UNITED STATES PATENT AND TRADEMARK OFFICE

APPLICATION NO.	FILING DATE	FIRST NAMED INVENTOR	ATTORNEY DOCKET NO.	CONFIRMATION NO.
10/563,660	01/06/2006	Miwa Okubo	09792909-6521	5305
26263 7590 07/31/2007 SONNENSCHN NATH & ROSENTHAL LLP P.O. BOX 061080 WACKER DRIVE STATION, SEARS TOWER CHICAGO, IL 60606-1080			EXAMINER ZIMMERMANN, JOHN P	
			ART UNIT 2861	PAPER NUMBER
			MAIL DATE 07/31/2007	DELIVERY MODE PAPER

Office Action Summary

FIG. 1

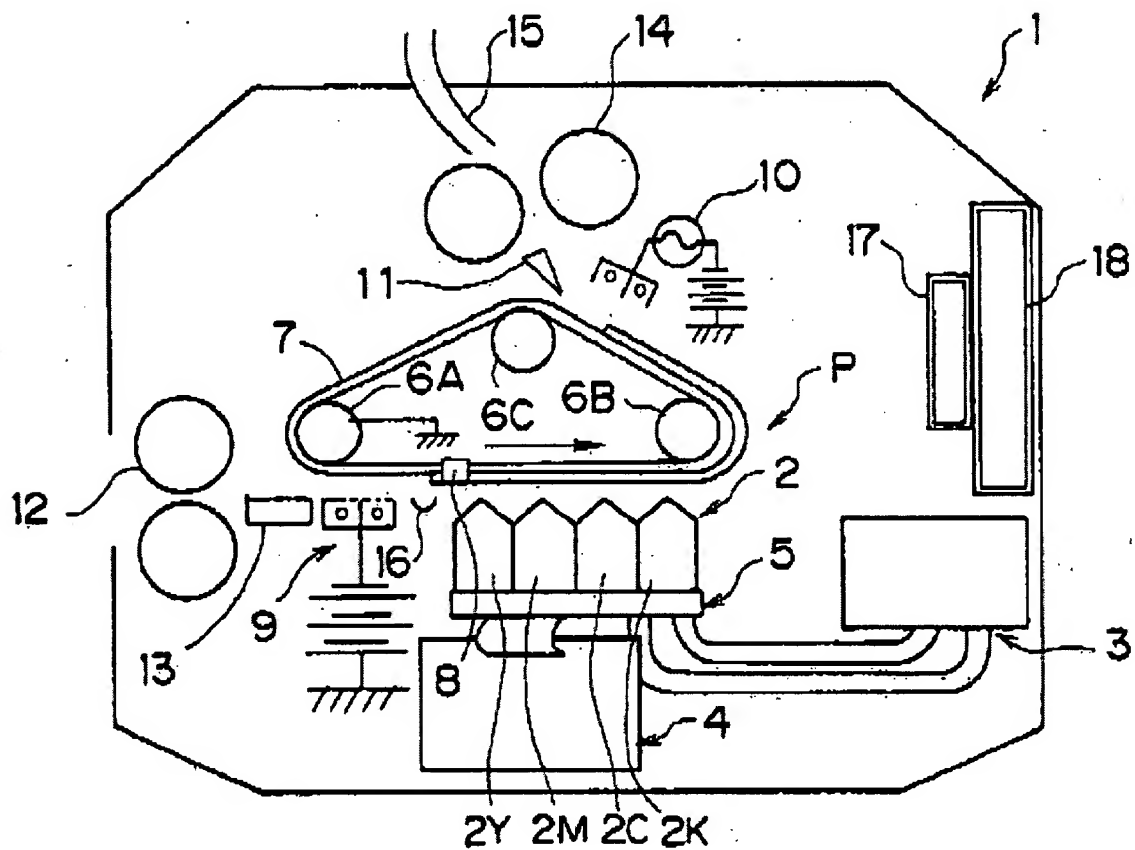
of colors from a discharge opening as droplets of ink to be attached onto a recording material (Nakazawa et al. – Background, Paragraph 5; Summary, Paragraphs 8 & 11; Detailed Description, Paragraph 58 and Figure 1, Reference #2Y, #2M, #2C & #2K, shown below).

d. Continuing with **claim 4**, Nakazawa et al. goes on to teach the case where the interval between a discharge of an ink of a first color and a discharge of an ink of a

second color is 200 mS or less [i.e. 67 μ S] (Nakazawa et al. – Examples, Paragraph 139), inks whose surface tension is 25 to 45 mN/m at 23° C. are used for said inks of each color (Nakazawa et al. – Detailed Description, Paragraphs 118 & 120).
